PRE-APPLICATION CONFERENCE NOTES

Breeze Creek Trail Subdivision (2023-029-PAC)

Meeting conducted on Wednesday, August 23, 2023 – 2 P.M.

Figure 2: Mapped erosion hazard area (in brown).

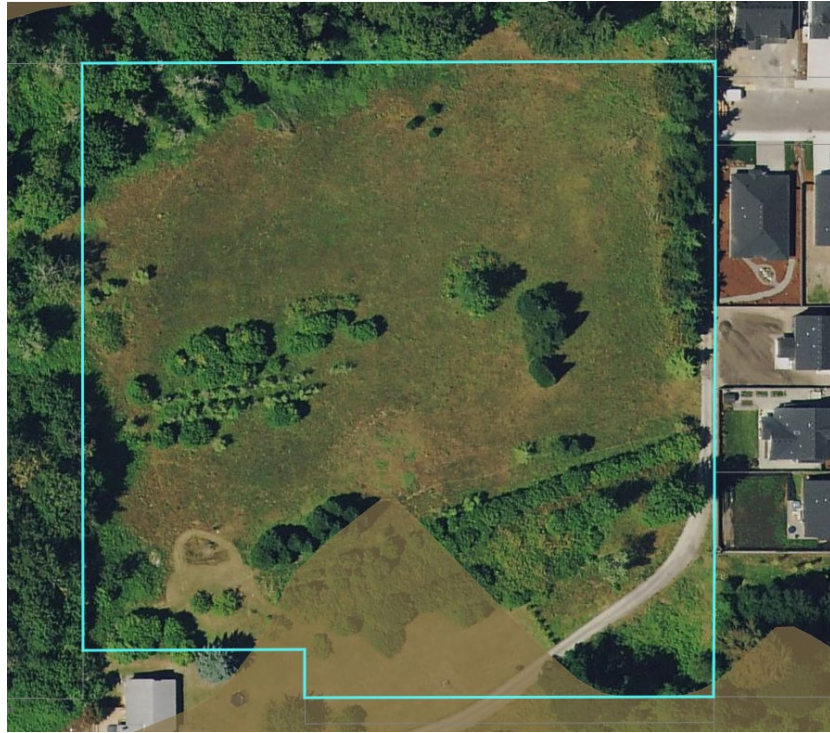
As shown in Figure 2, the southern portion of the project site has a mapped severe erosion hazard area. Additionally, Figure 3 indicates areas of slopes greater than fifteen percent and potential instability on the northwest and southeast corners of the project site.

Figure 5: Risk of Encountering Archaeological Resources

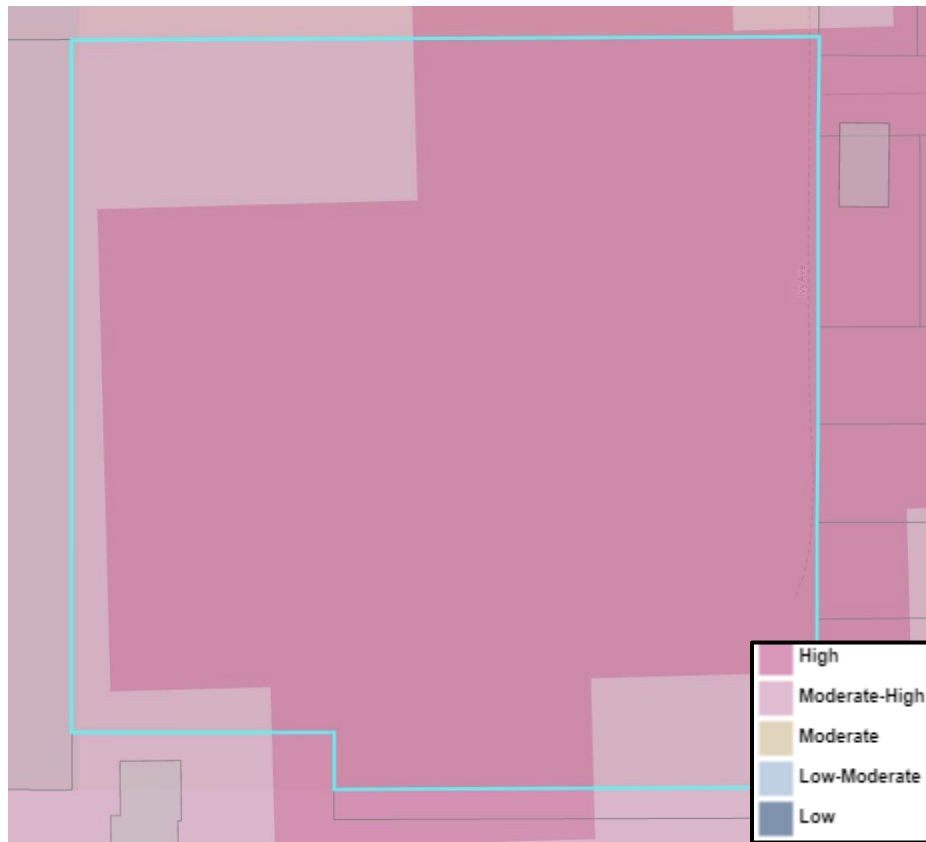
Using Clark County MapsOnline, Figure 5 shows the site is identified as having a moderate-high to high risk of containing archaeological resources and must file an archaeological predetermination report as per Table 18.360.020-1. Predetermination reports must contain the information in 18.360.080(4). Based on the findings of the predetermination report, further archaeological work or a full archaeological survey may be required.
